# SITE PLAN WITH ADJUSTMENTS

# 2252 TOWER ROAD

### COVER SHEET

## SEMI-TRAILER TRUCK TURNING ANALYSIS

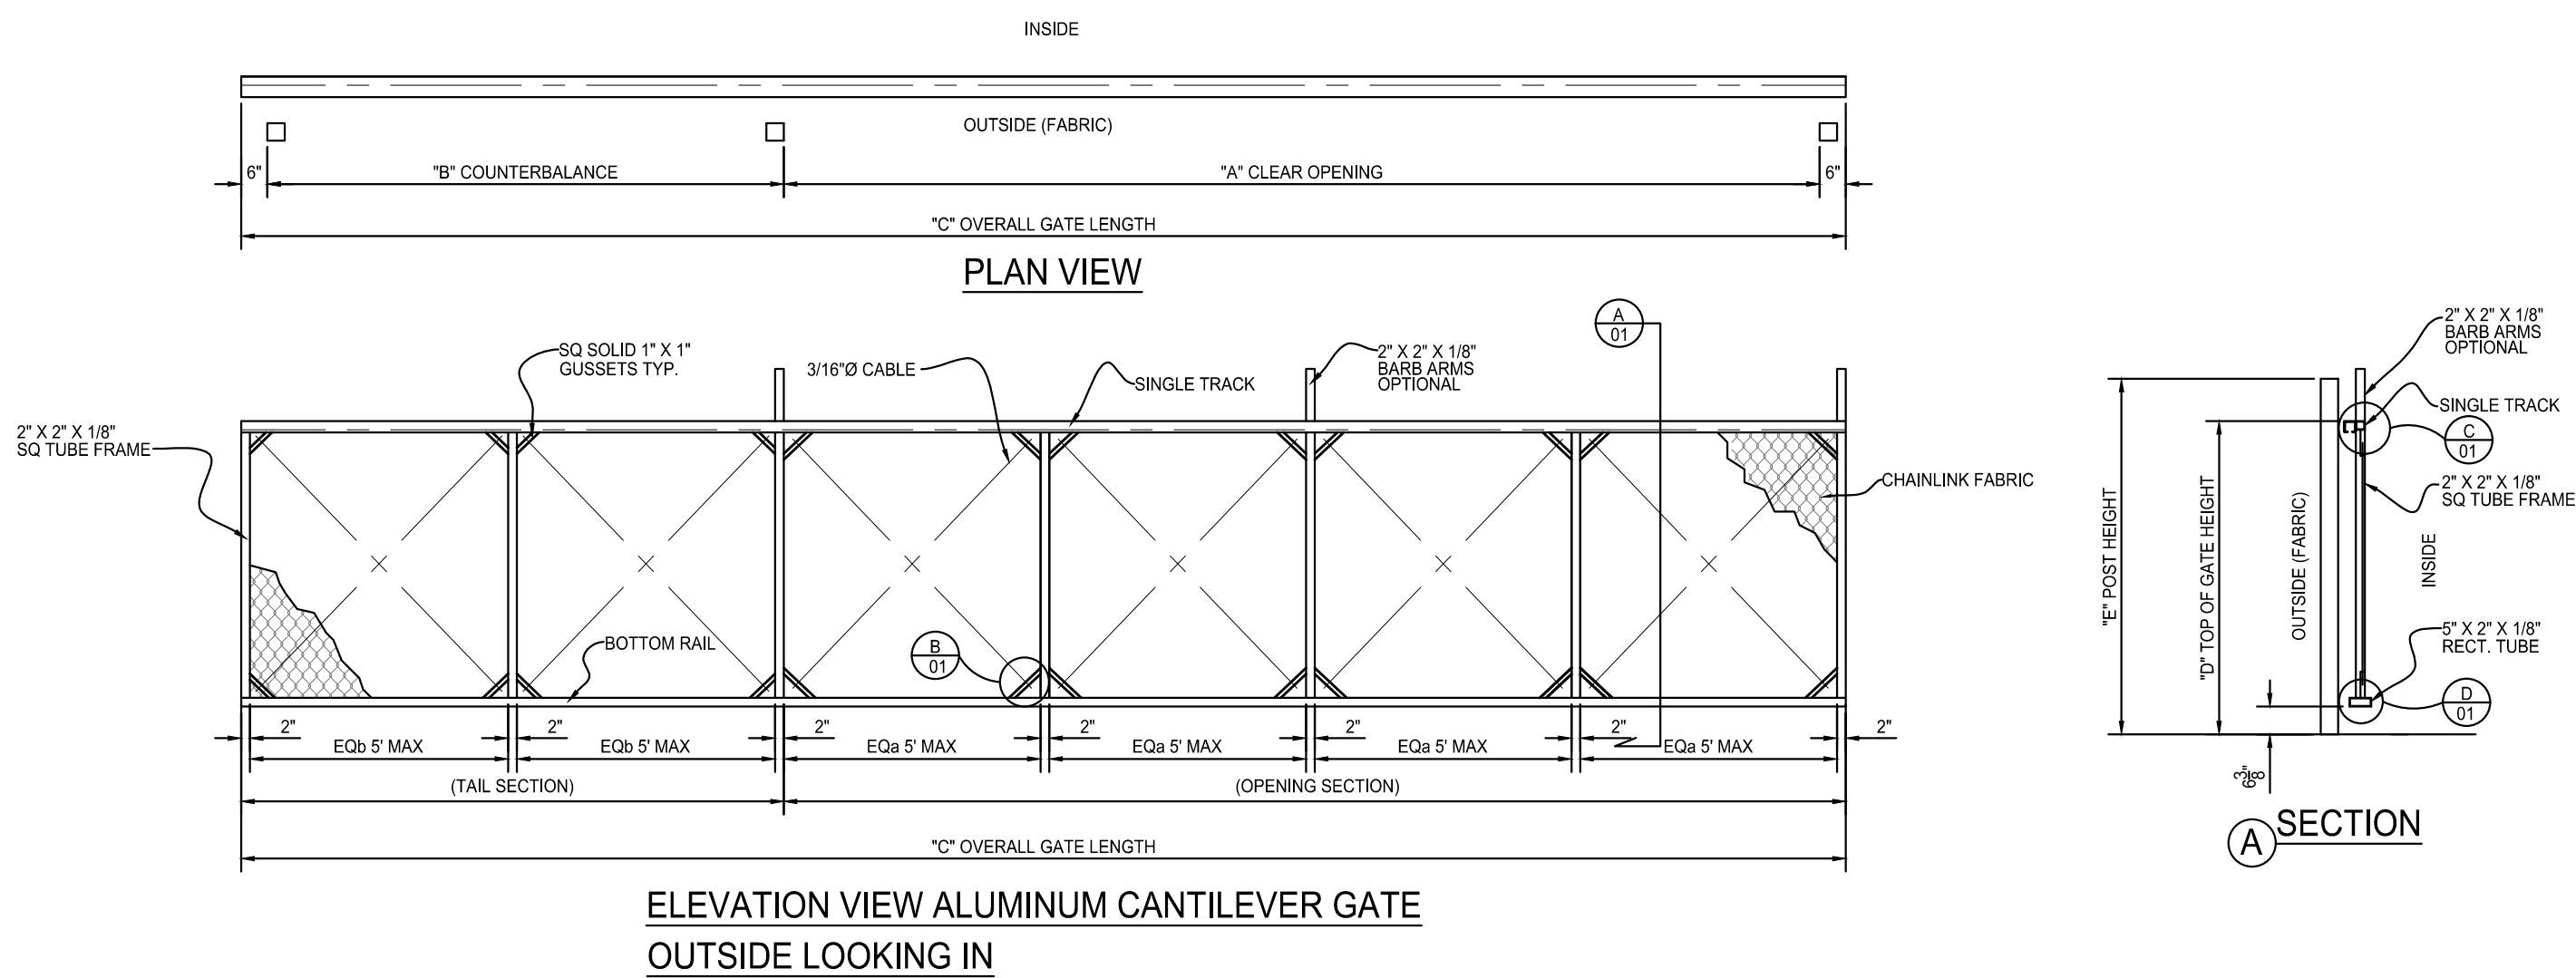
Please revise gate label to match the label on sheet 5.

DETAIL 1 CHAIN LINK SINGLE TRACK ALUMINUM CANTILEVER GATE  
N.T.S

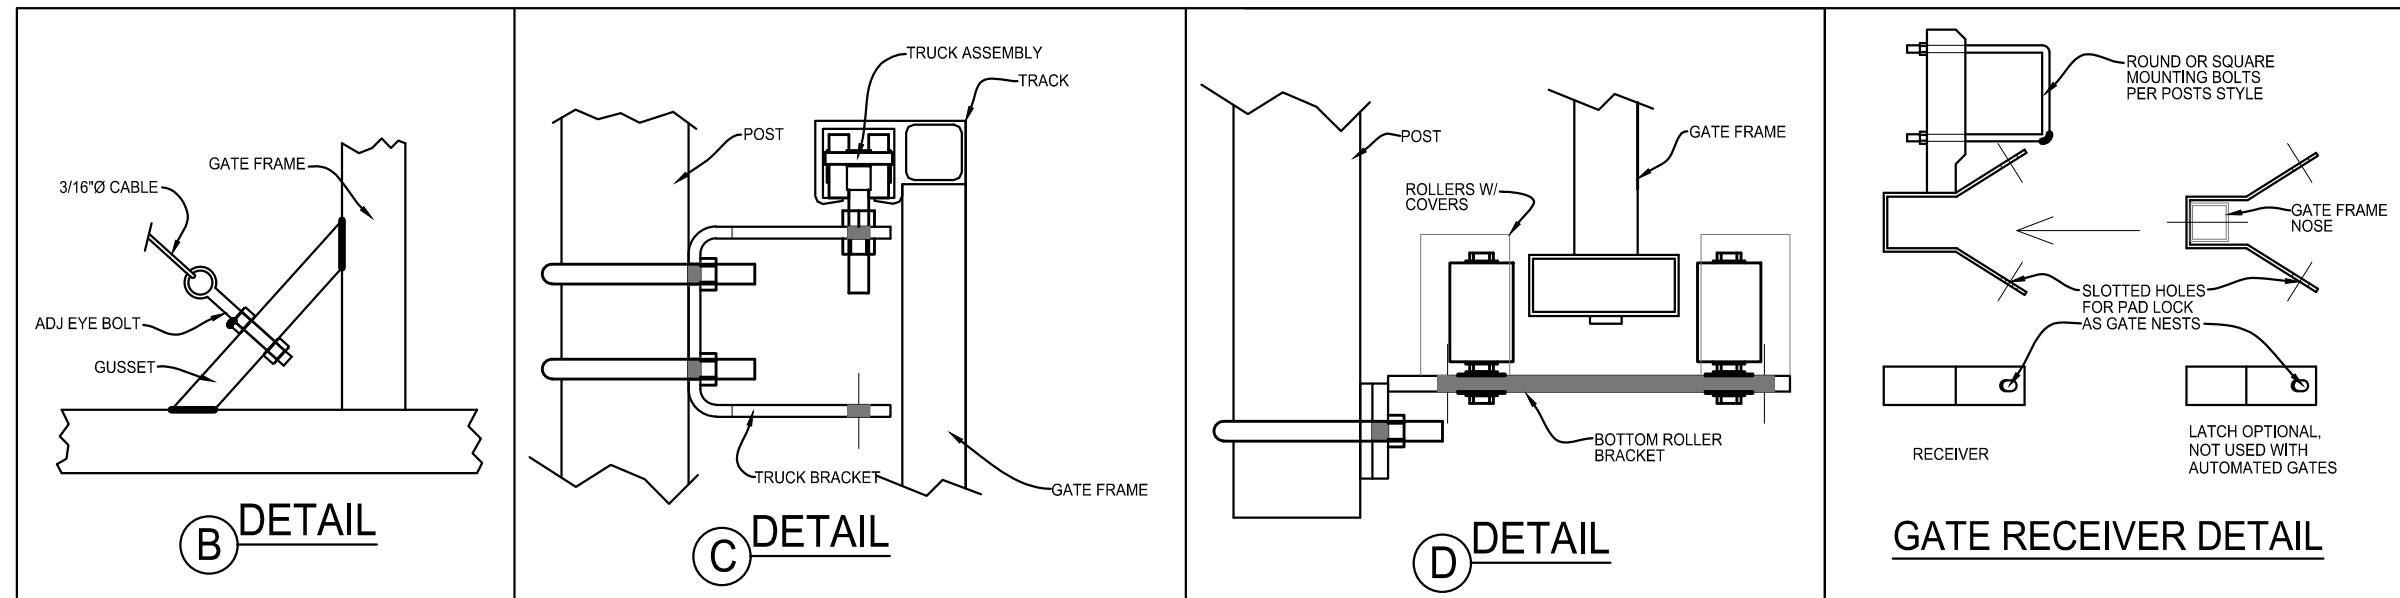
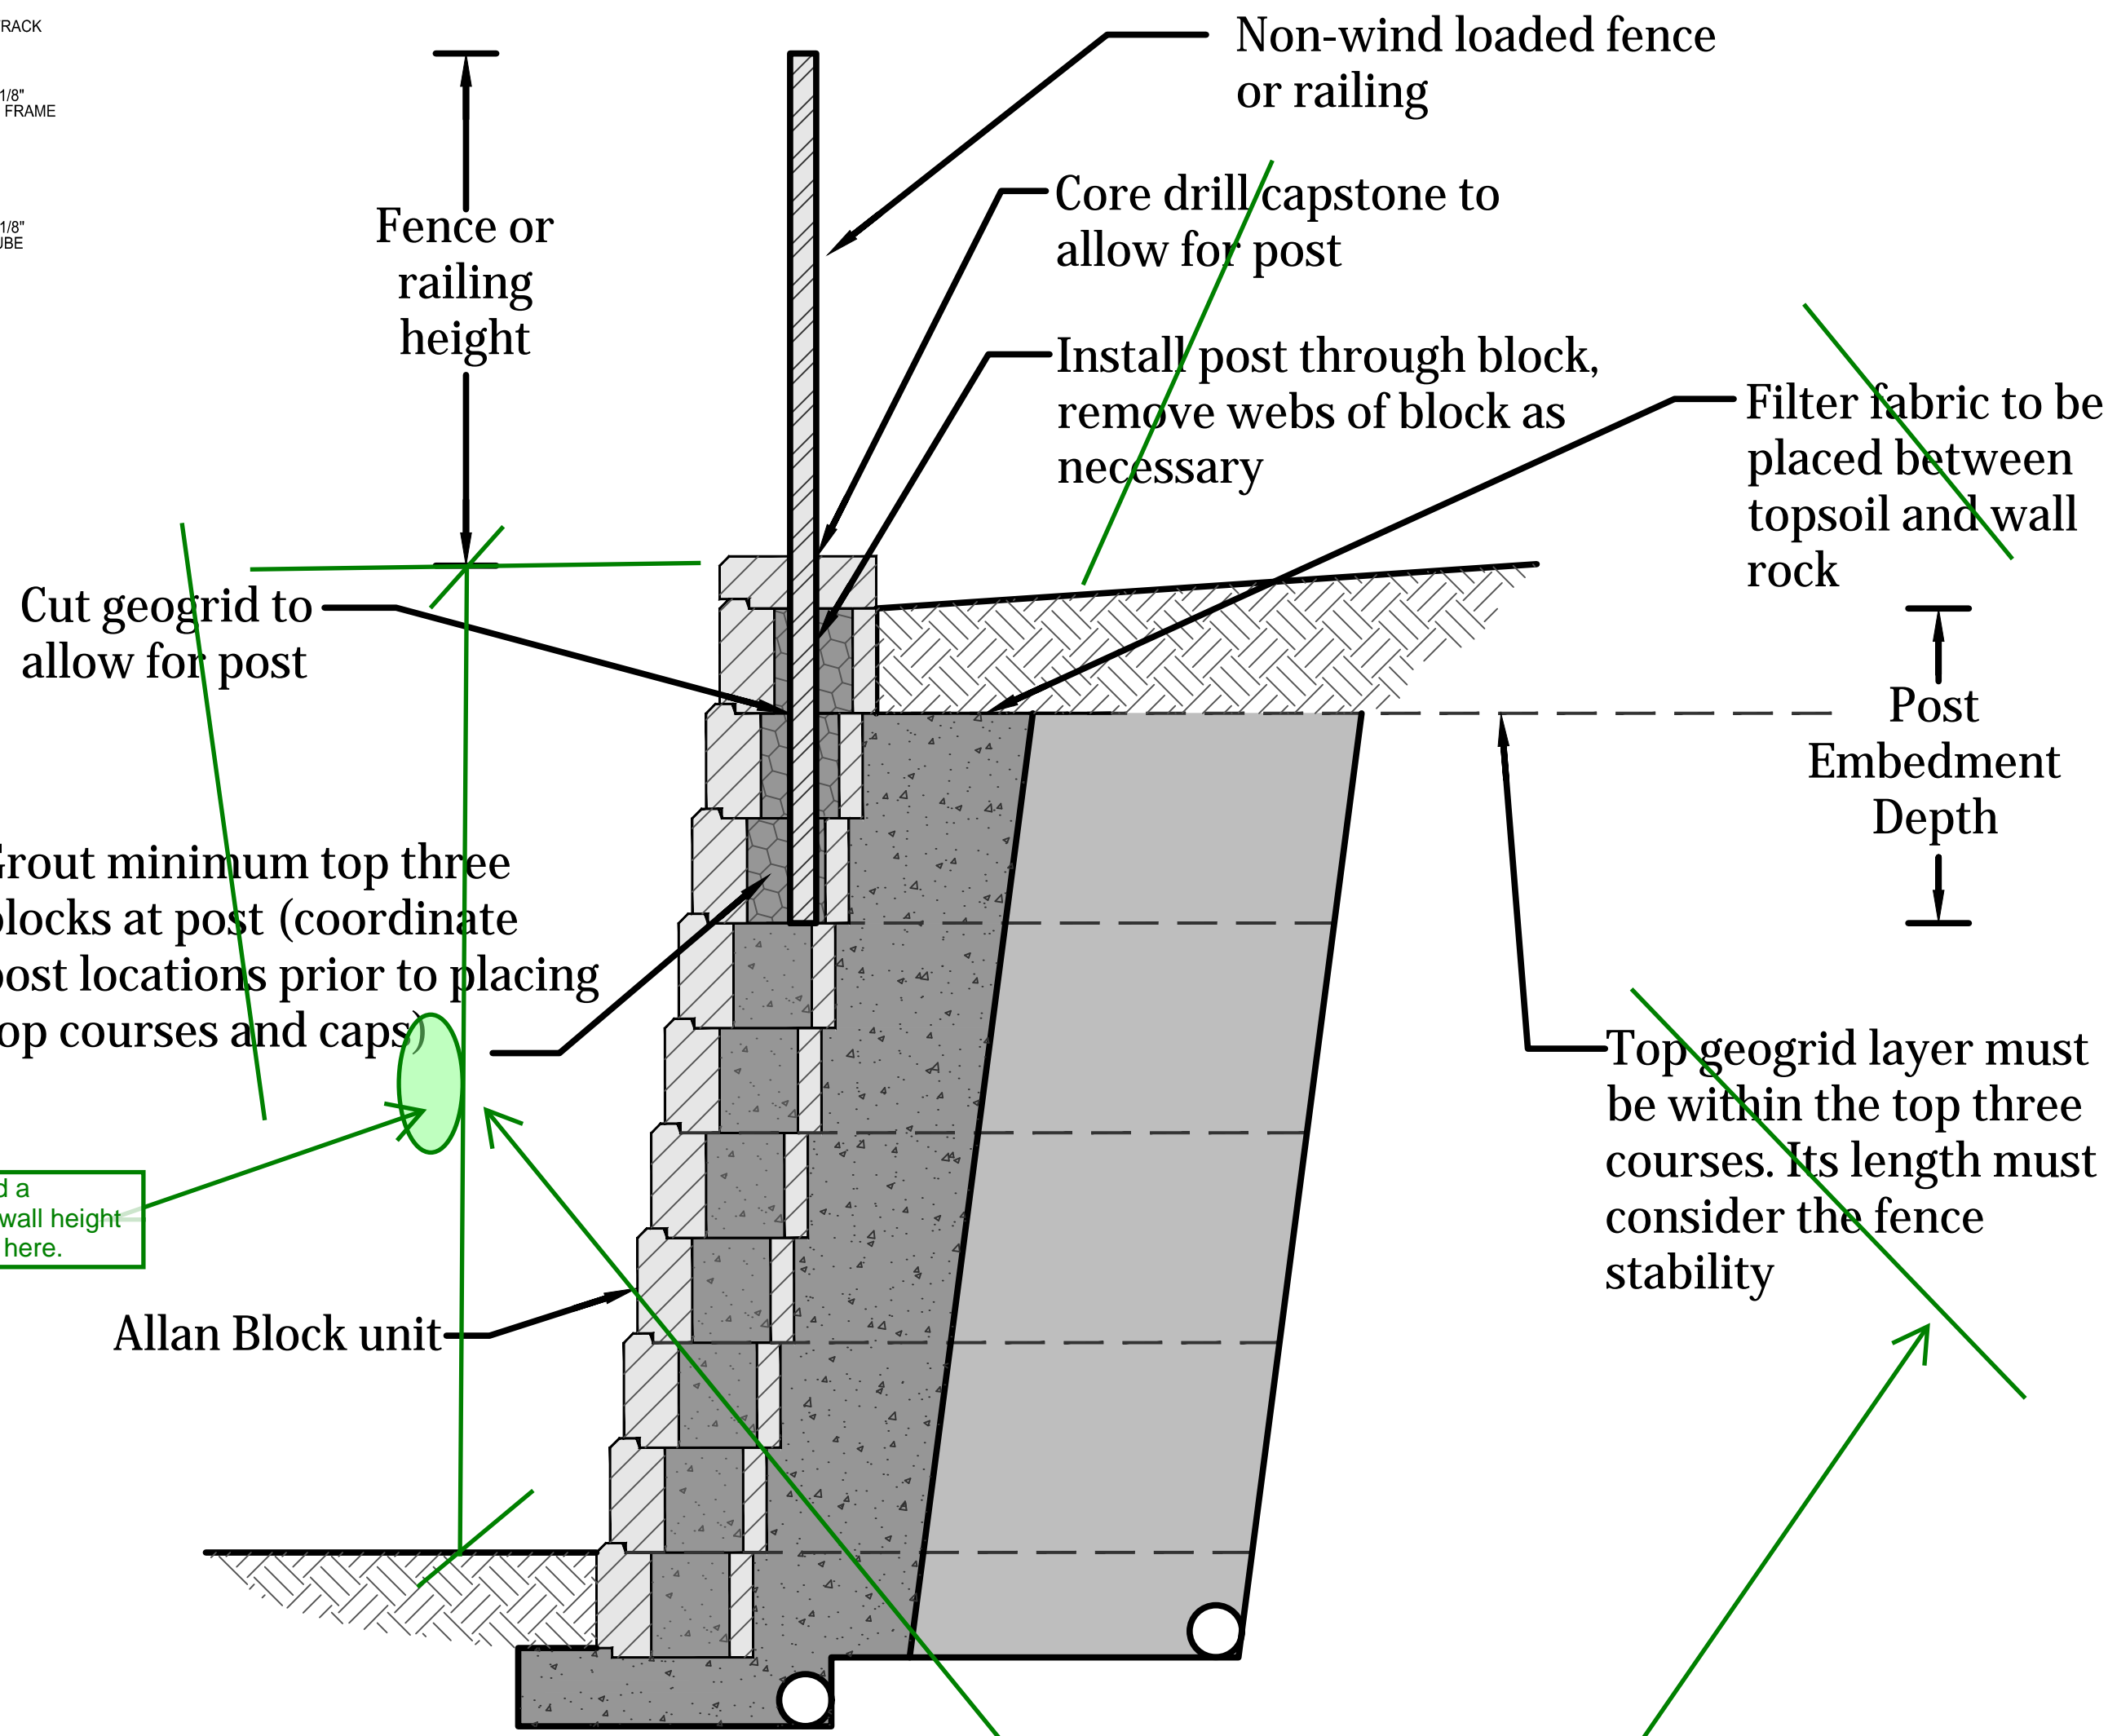
Please remove any crossed out level of detail from the site plan and only include this level of detail in the civil plan submittal. Please add a maximum height dimension to this detail.

9J. Please remove any crossed-out level of detail from the site plan and only include this level of detail in the civil plan submittal. Please add a maximum height dimension to this detail.
